**NEA/RWM/PEER(2012)2/PROV**

**THE POST-CLOSURE RADIOLOGICAL SAFETY CASE FOR A SPENT FUEL REPOSITORY IN SWEDEN**

**An international peer review of the SKB license-application study of March 2011 (Draft final report)**

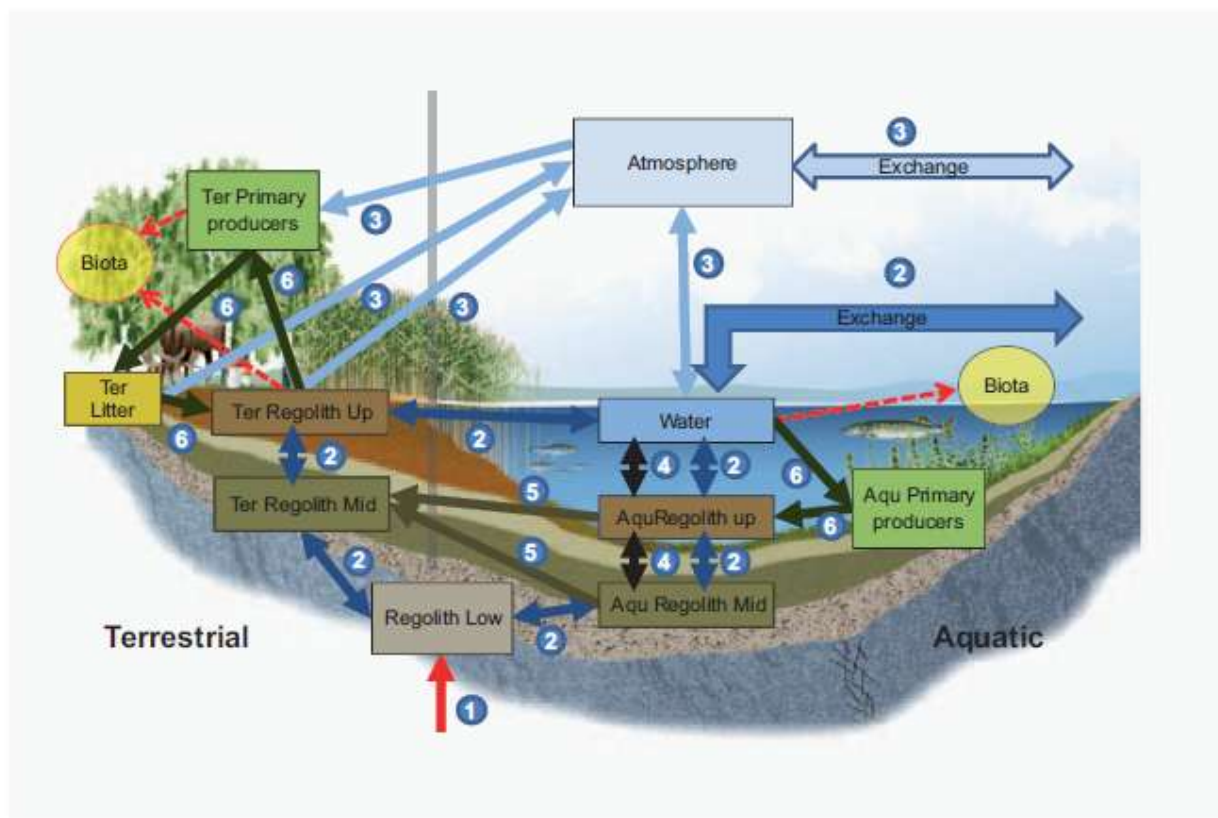
The radionuclide model for the biosphere is a compartment model, where system components that are considered internally homogeneous in their properties are represented by distinct compartments. This is standard practice. The compartment model SKB uses is illustrated in Figure 13-6 in TR-11-01, and is reproduced below. This figure clearly illustrates the various compartments and their connections. The IRT finds SKB's compartments and connections between compartments appropriate.

SKB’s assessment of the dose is based on a strong international cooperation in Biosphere assessments. The biosphere analysis for the safety assessment of SR-Site relies upon the application of the IAEA BIOMASS methodology. The exposure of the most exposed group was calculated for a constant release rate of radionuclides to the biosphere, and for a pulse release. Environmental activity concentrations were used to assess the radiological impact on the environment. Only one group is explored (considered as the most exposed group): a family farming wetlands. The justification for this group is its complete self-sufficiency with respect to food and drinking water supply. However, the IRT is of the opinion that some points would benefit from a more precise justification:

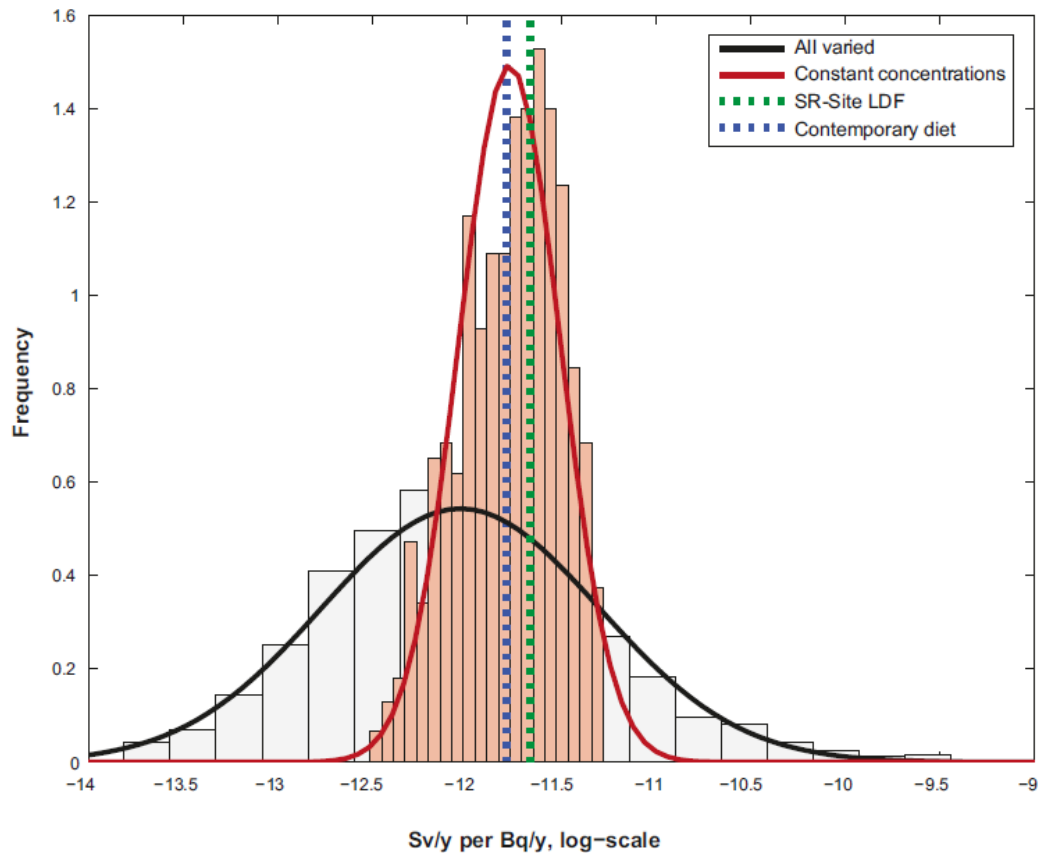
For the dose-dominating Ra-226, SKB notes the partitioning coefficient between the solid and liquid phases (i.e. the  $K_d$  value) for the lower regolith layer explained approximately 60% of the overall uncertainty, and additionally 7% was explained by  $K_d$  for the upper and mid-regolith layers. SKB's main reason for the large variation in  $K_d$  value for Ra-226 was that the available site data were insufficient to give a reliable estimate of the natural variation. Instead, SKB estimated the  $K_d$  value for Ra-226 from literature data spanning a wide range of geographical conditions and soils types. These seem like reasonable conclusions and approaches.

However, SKB notes that use of literature data "clearly exaggerate the uncertainty of Ra-226 retention at the site". Thus, SKB decided to use the uncertainty in the Ra-226  $K_d$  estimated from the site data in the probabilistic simulations that addressed the effect of parameter uncertainty. The resulting LDF uncertainty spans several orders of magnitude as shown in the figure below (Figure 12-3 reproduced from TR-10-09). Given the importance of Ra-226 in the SKB assessment, and the lack of site-specific data for  $K_d$  values for Ra-226, the IRT encourages SKB to attempt to provide better site-specific data for future assessments if at all possible. SKB should also consider that such a large uncertainty in the Ra-226 LDFs could mean that better data would result in some other radionuclide or radionuclides dominating the overall dose rate to the most exposed group. This further underscores the usefulness of obtaining additional, site-specific data for Ra-226.

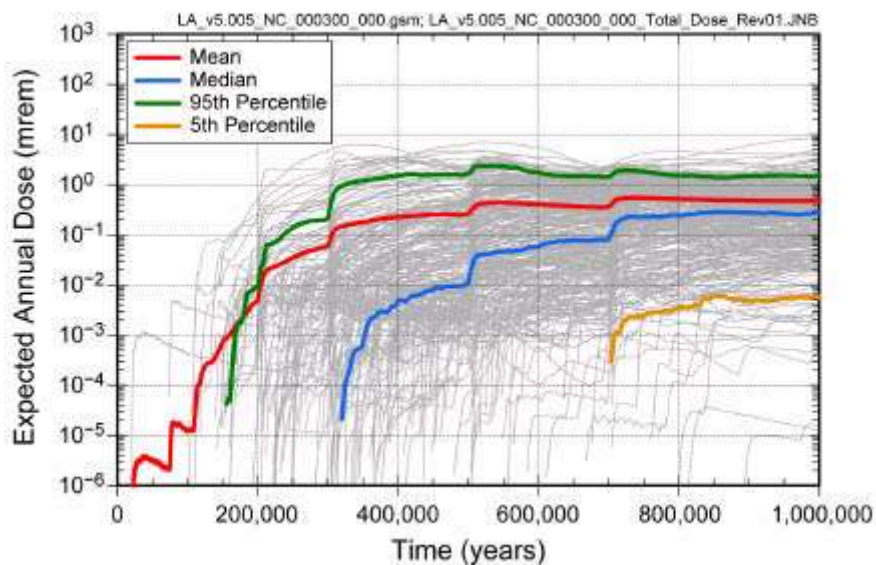
The evaluation of scenarios allows for the calculation of a dose and risk summation, and the conclusions whether the regulatory risk criterion is fulfilled. The risk dilution issue is addressed in a rigorous manner (TR-11-01, chapter 13.9.4): SKB explicitly considers the case of short term releases and calculates an “accumulated short-term risk”, following the method suggested in Appendix 1 to SSMFS 2008:37. The result is below the risk limit.

Although the dose calculation based on the technical conclusions drawn from scenarios analyses is sound, the IRT submits the following comment on the presentation of the result: The risk summation curve presents pulse-like features and this is actually an artefact due to the small number of realisations leading to canister failure. Although this does not have any consequence for the demonstration of risk compliance, it is a weakness with respect to the clarity of the demonstration for two reasons:
